Service Bulletin No: 91-001
Modification No: EC-19-0553

**AIR VEHICLE WIRING - GENERAL
IMPROVEMENTS TO THE AIRCRAFT ELECTRICAL HARNESS INSTALLATION**

PC-24 aircraft MSN 101 thru MSN 160.

To improve the electrical harness installation, at various locations throughout the aircraft, to prevent the possibility of the electrical harness chafing on the structure and/or moving parts.

Improvements to the electrical harness installation - Wing fairing
Figure 5 (Sheet 4 of 9)

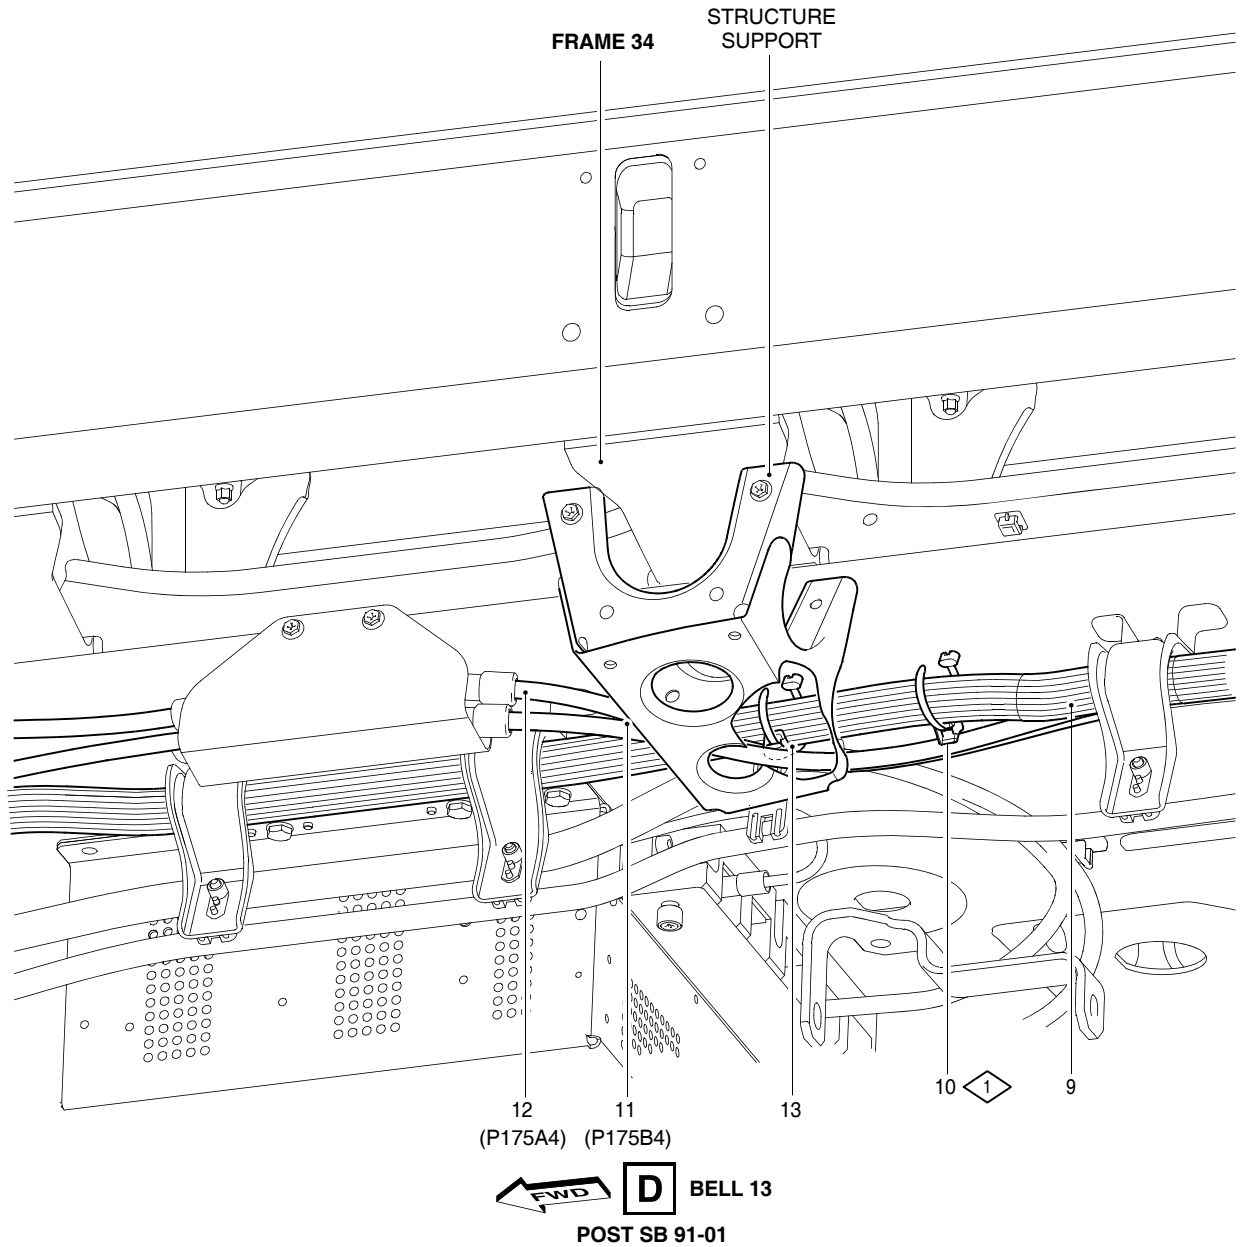
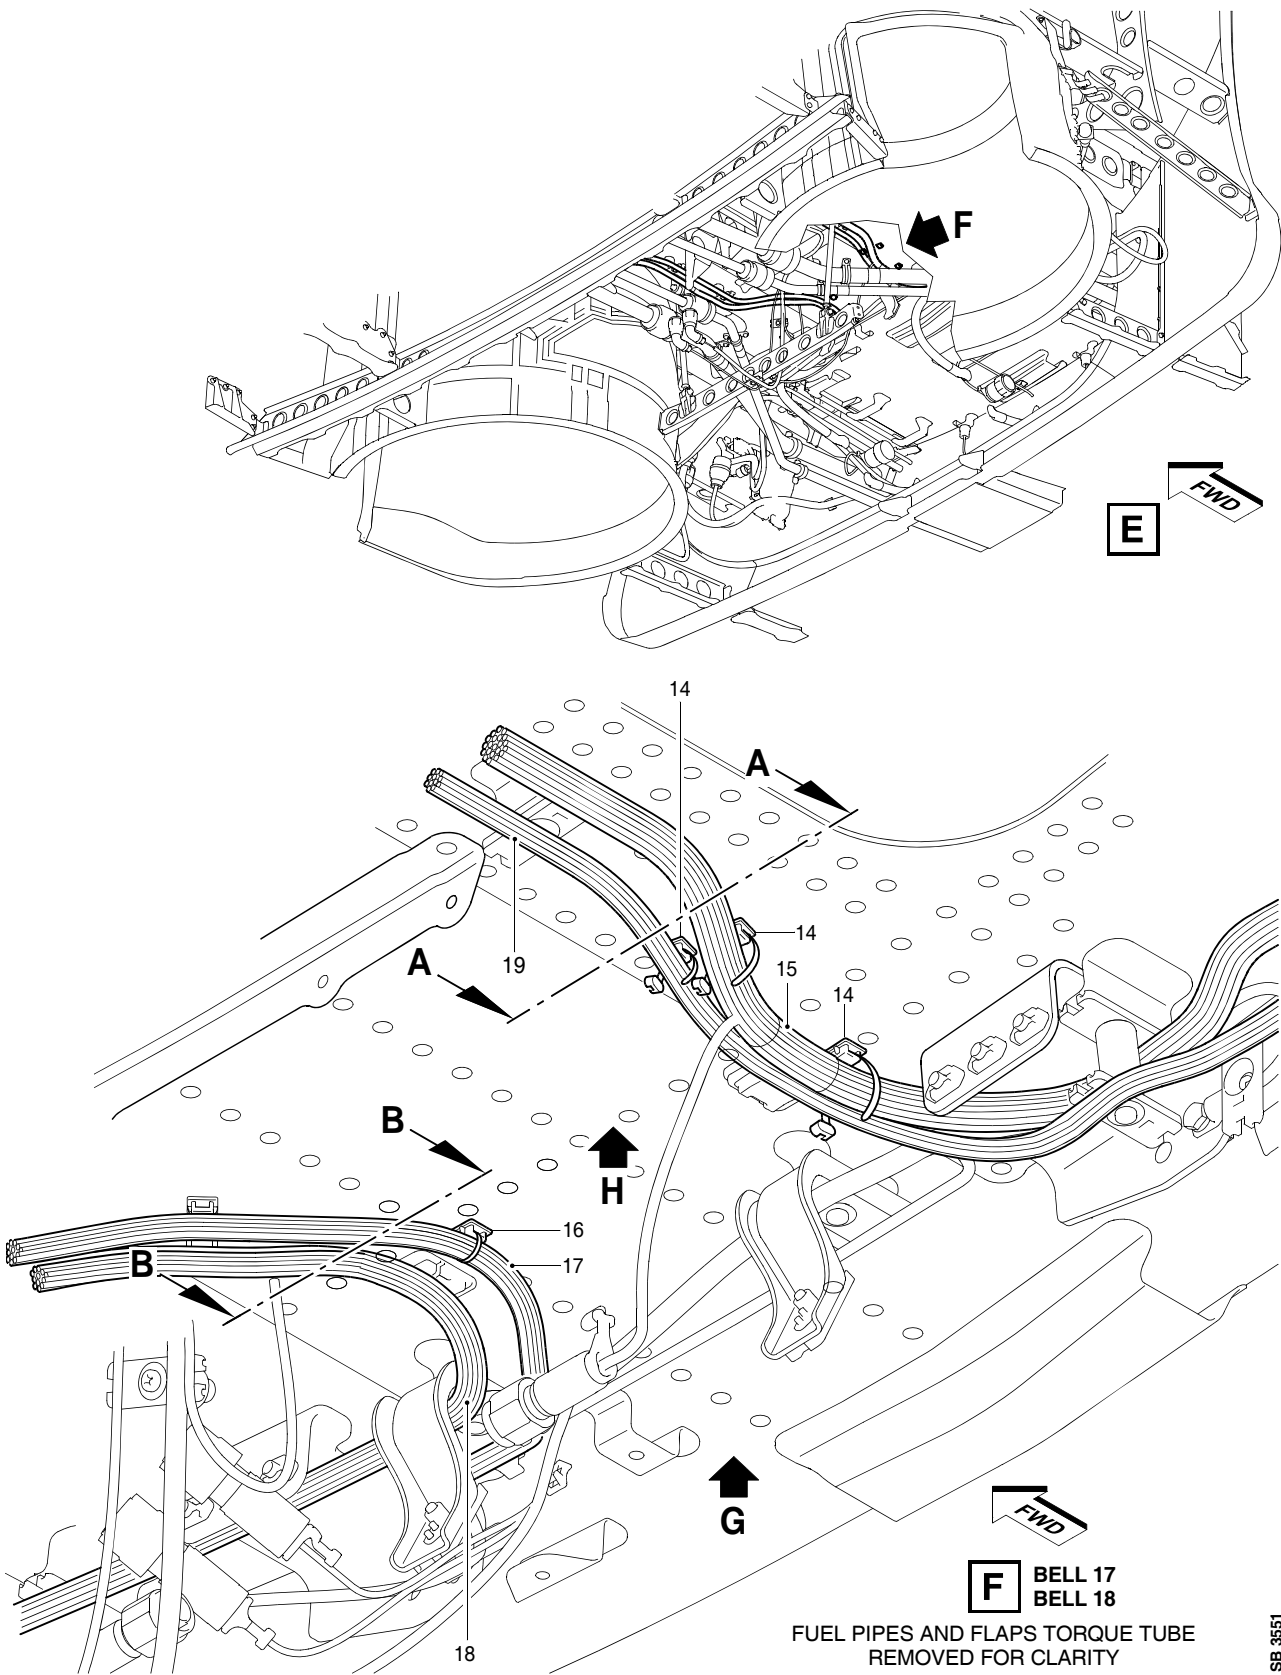
- (3) **Improvement to prevent the electrical harness from chafing on the structure.**
Refer to Figure 5 (Sheet 4 and 5)

At the LH structure support below Frame 34, between the essential feeder 4 (P175A4), the essential feeder cable (P175B4) and the electrical harness:

- (a) Cut and remove the necessary cable ties from the electrical harness (9), the essential feeder cable (11) (P175B4) and the essential feeder 4 (12) (P175A4) to get sufficient access to install the new spacer (13) (P/N 971.32.18.106), and move the existing spacer (10).

- (c) Remove and keep the spacer (10).
- (d) Put new tape (Silicone red, fiberglass) (Material No. P09-064) around the electrical harness (9), the essential feeder cable (11) (P175B4) and the essential feeder 4 (12) (P175A4) at the two installation positions for the spacers (10) and (13).

- (h) Use the applicable new cable ties (Material No. P09-005/P09-008/P09-014) to:
 - Attach the new spacer (13)
 - Replace any cable ties that you cut and removed to get access.

Improvements to the electrical harness installation - Wing fairing
Figure 5 (Sheet 6 of 9)

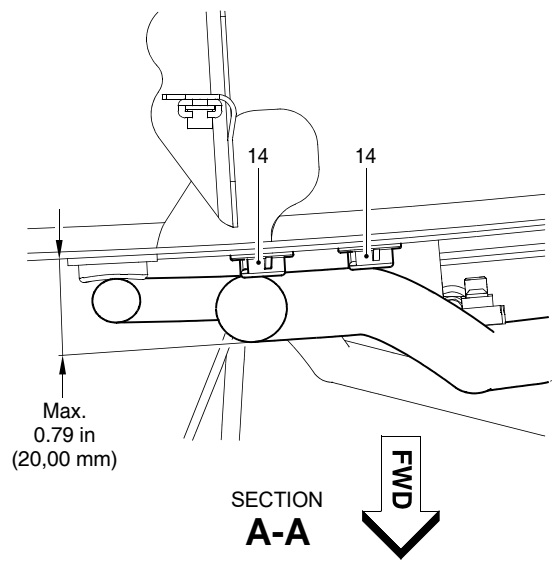
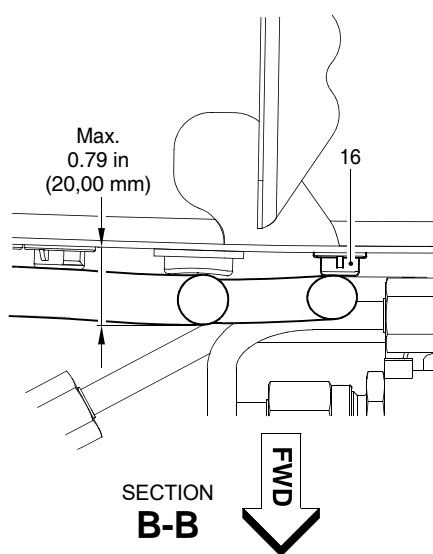
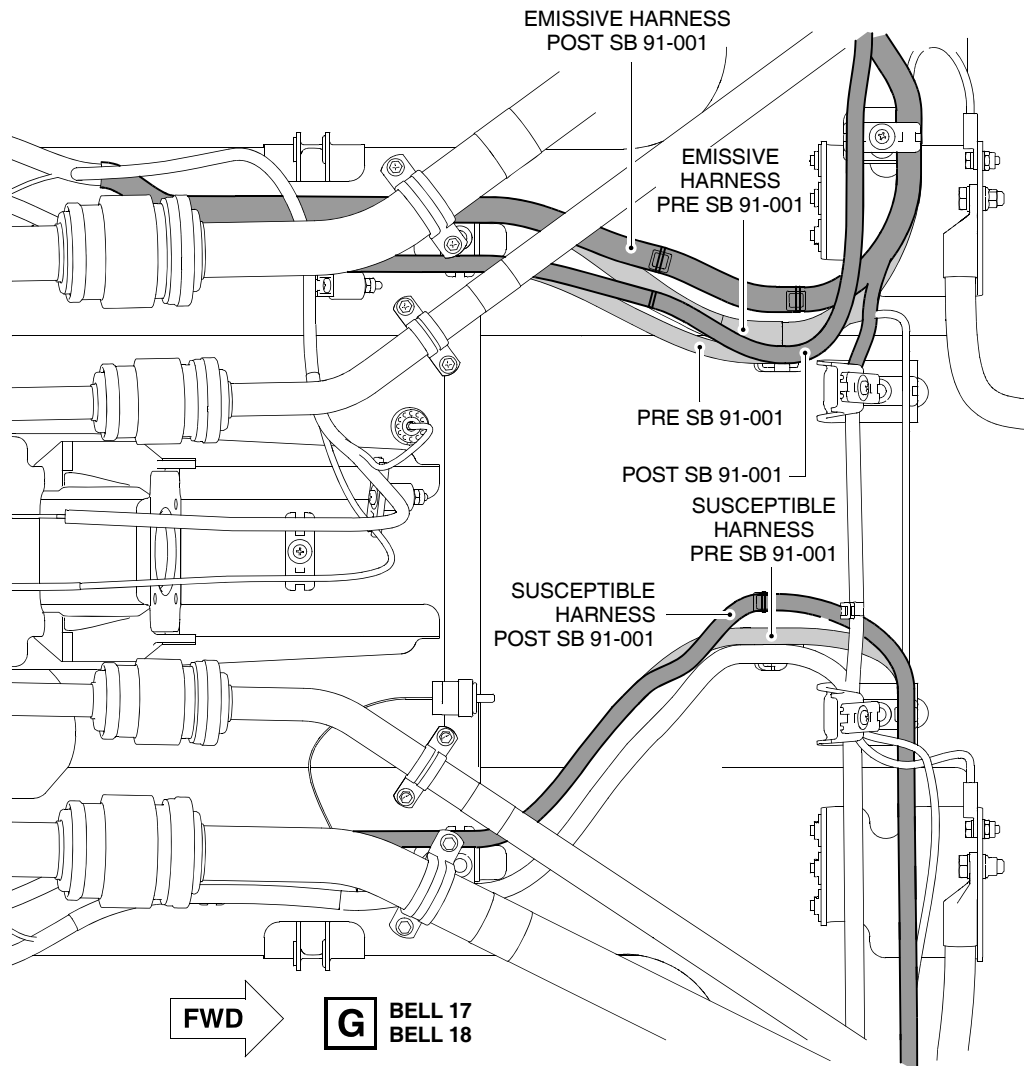
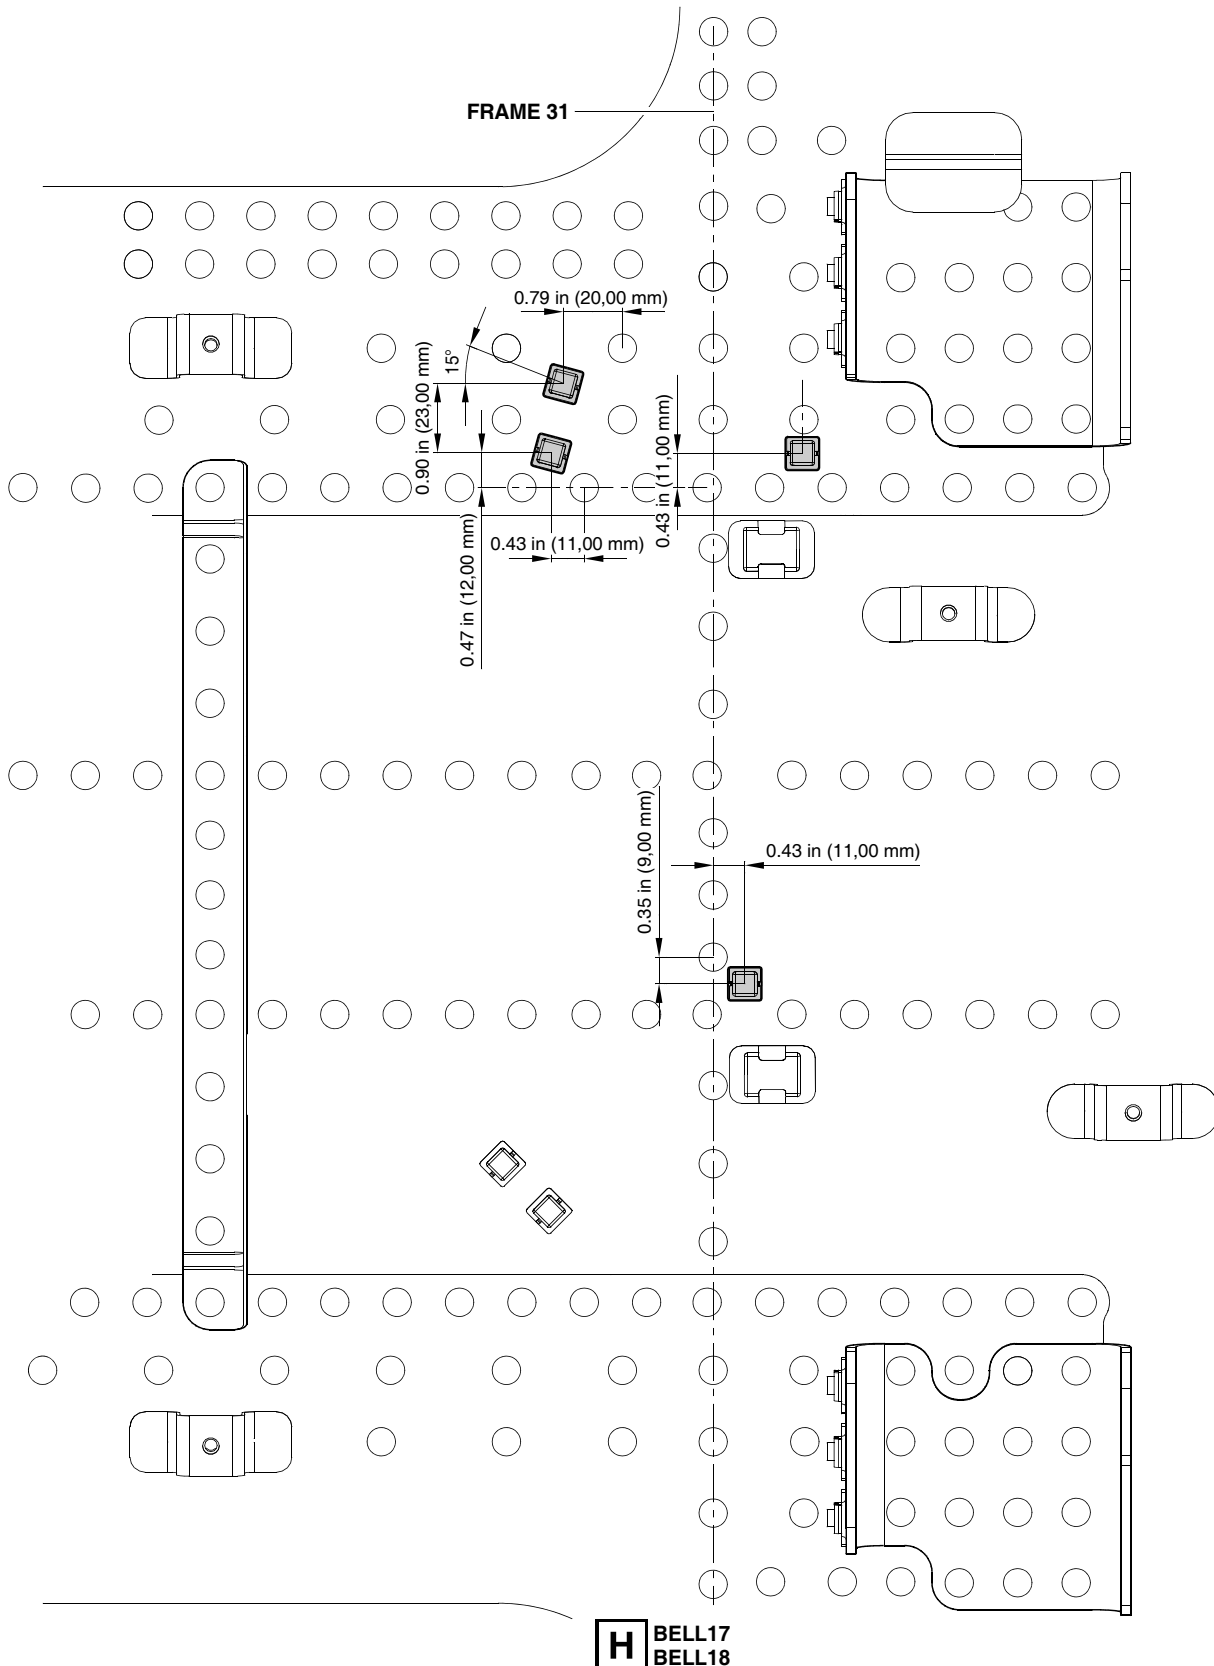
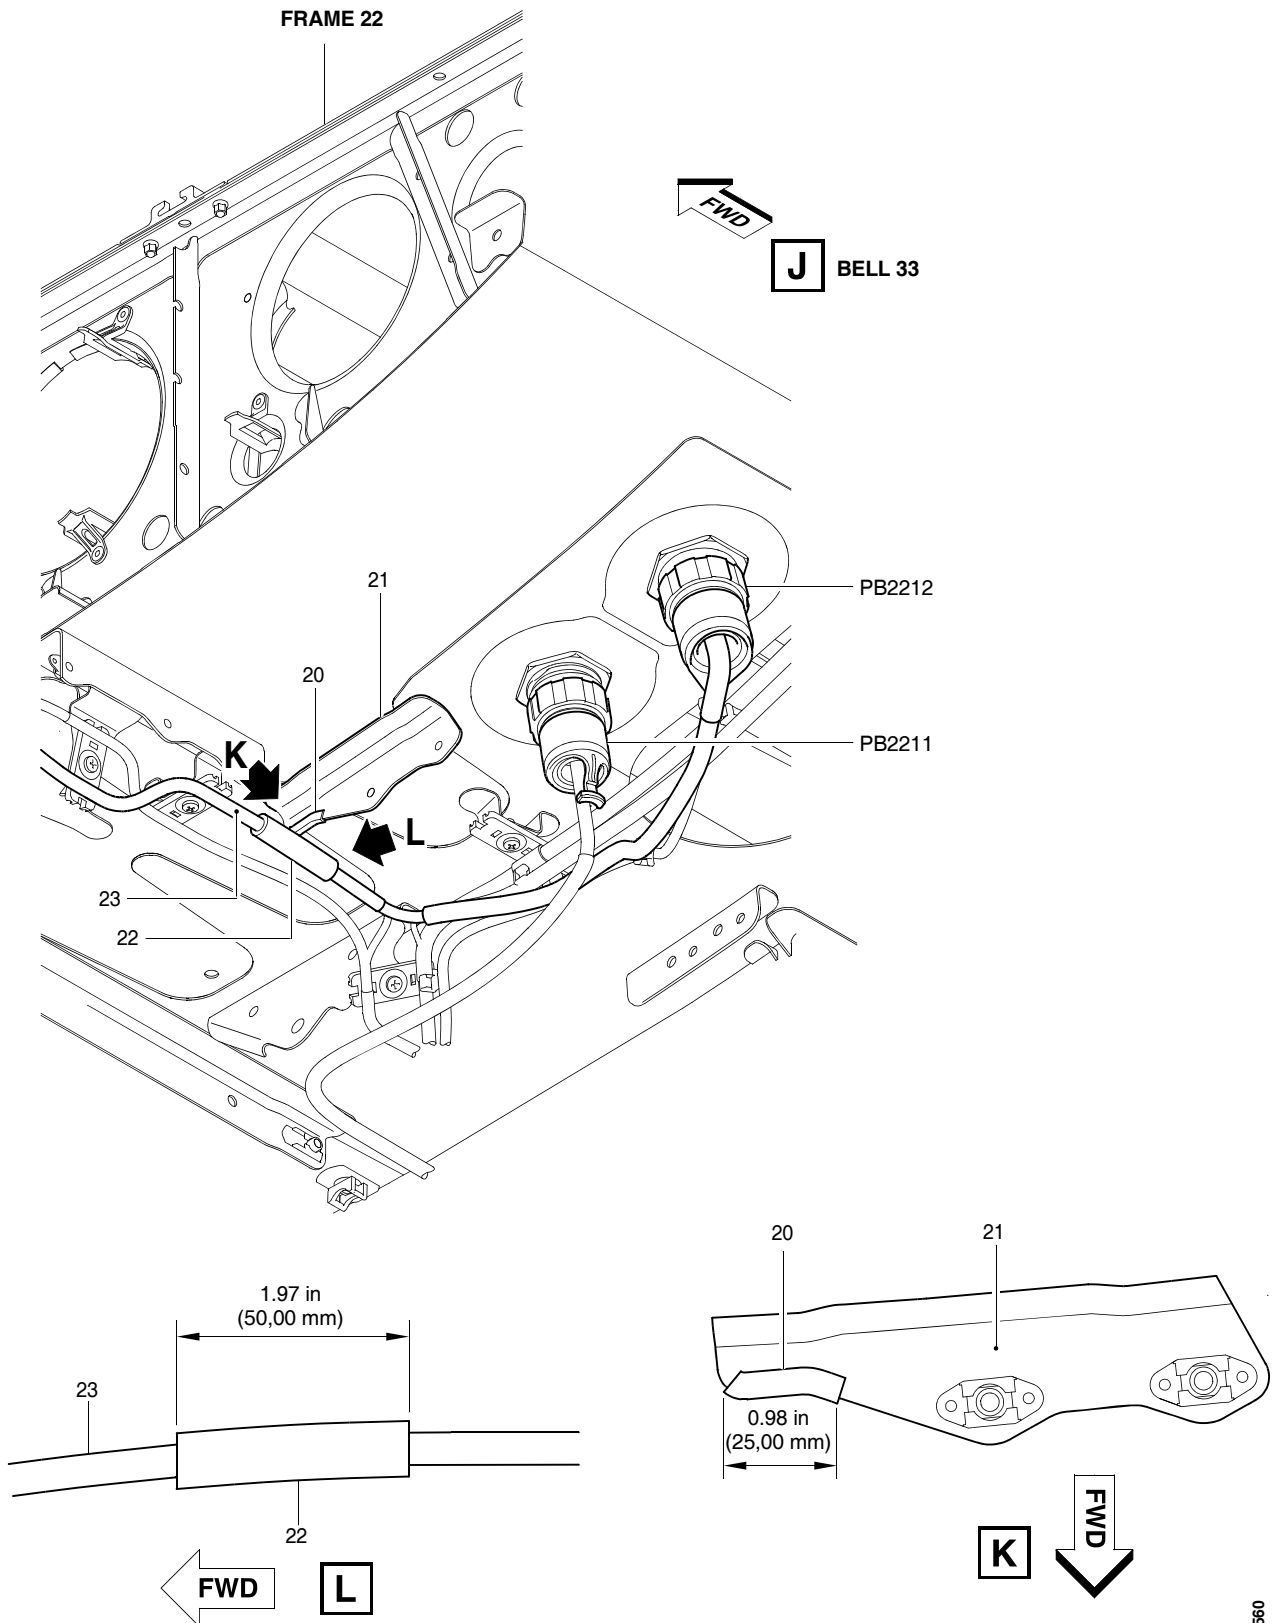
- (4) Improvement to prevent the electrical harness from chafing on the flaps torque tube assembly. Refer to Figure 5 (Sheet 6, 7 and 8)

- (a) Cut and remove the necessary cable ties and tape (silicone red, fiberglass) to get sufficient access to:
- Install the three new cable mounts (14) (P/N 971.32.18.251) on the LH side
 - Install one new cable mount (16) (P/N 971.32.18.251) on the RH side
 - Modify the route of the emissive harness (15) on the LH side, and the susceptible harness (17) on the RH side.

NOTE: The maximum permitted distance from the aircraft skin to the lowest part of the electrical harness is 0.79 in (20,00 mm). Refer to Figure 5 (Sheet 7, Section A-A)
 - 2 Put one layer of new tape (Silicone red, fiberglass) (Material No. P09-064) around the emissive harness (15), and the susceptible harness (19), at the applicable new cable mount (14) installation positions.
 - 3 Route the emissive harness (15) to the position of the two new outboard cable mounts (14).
 - 4 Use the applicable new cable ties (Material No. P09-005/P09-008/P09-014) to install the emissive harness (15) on the two new cable mounts (14).
 - 5 Route the susceptible harness (19) to the position of the new inboard cable mount (14).

NOTE: The maximum permitted distance from the aircraft skin to the lowest part of the electrical harness is 0.79 in (20,00 mm). Refer to Figure 5 (Sheet 7, Section B-B).
